Planning

CHRIS O'HARE

222 KNOWSLEY LANE

Site Plan

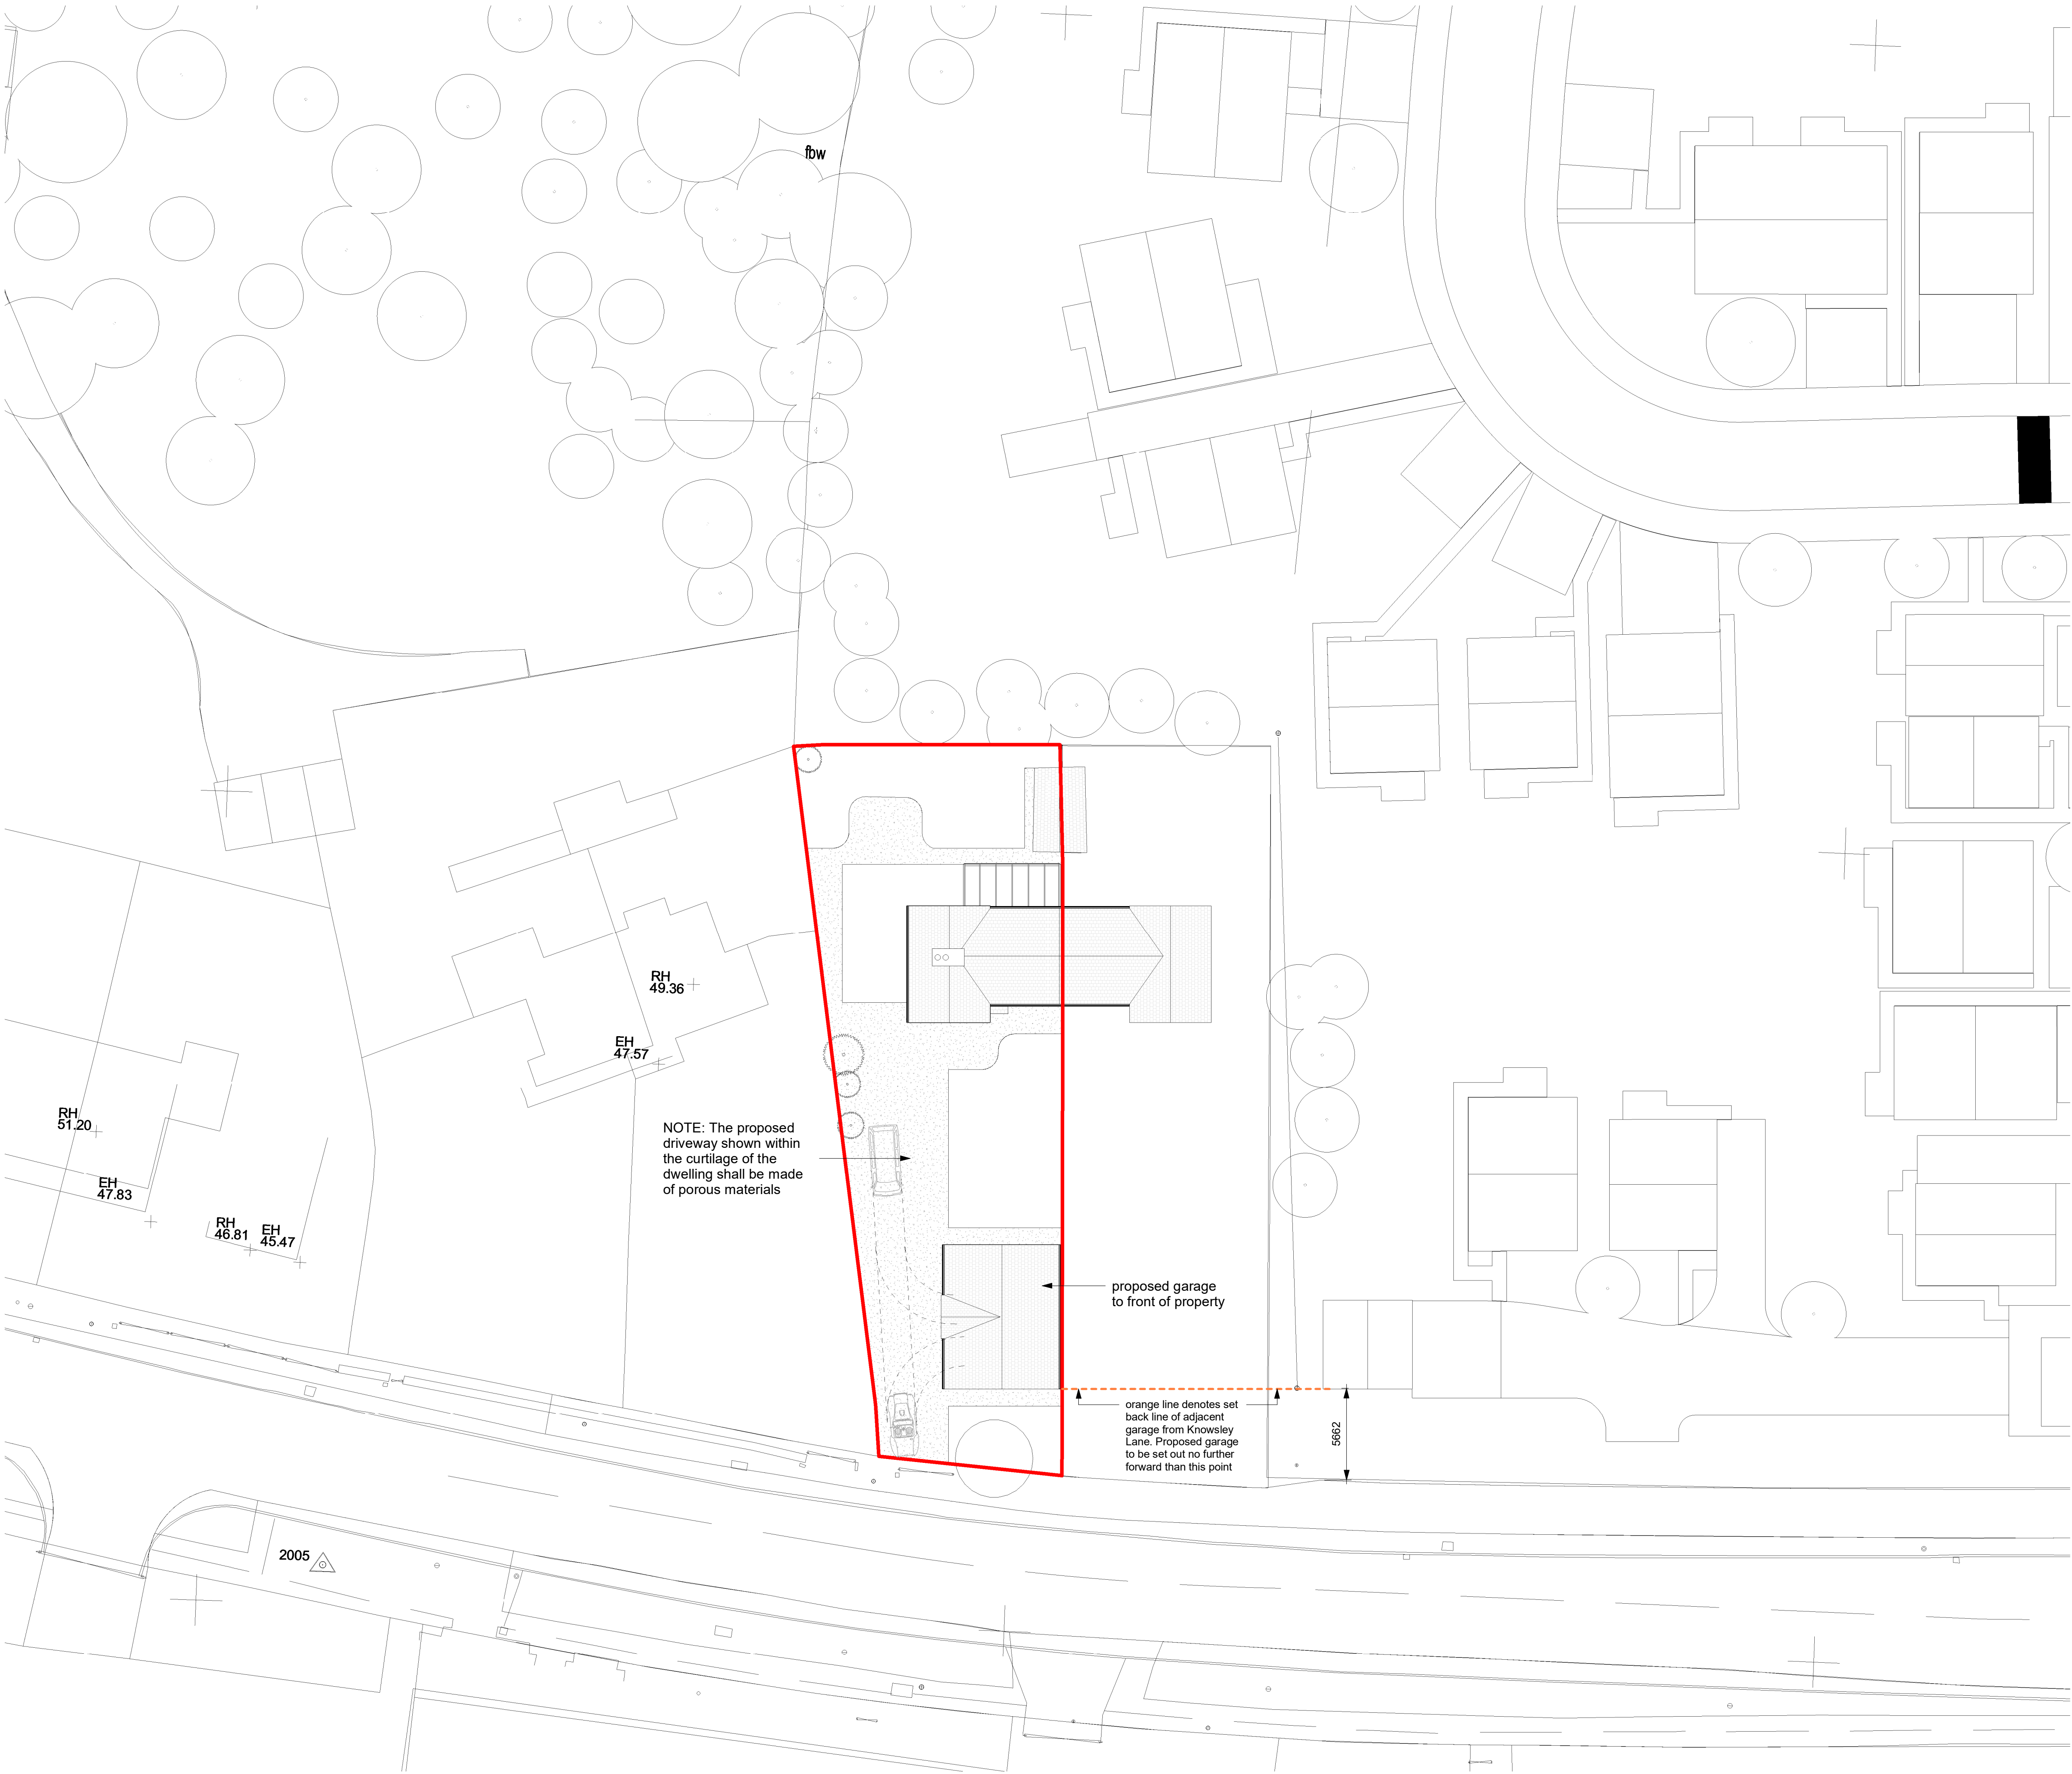
P1	Proposed Garage set back in accordance with local authorities comments	SMU	CoH	30/07/2024
Rev.	Description	Drawn	Checked	Date
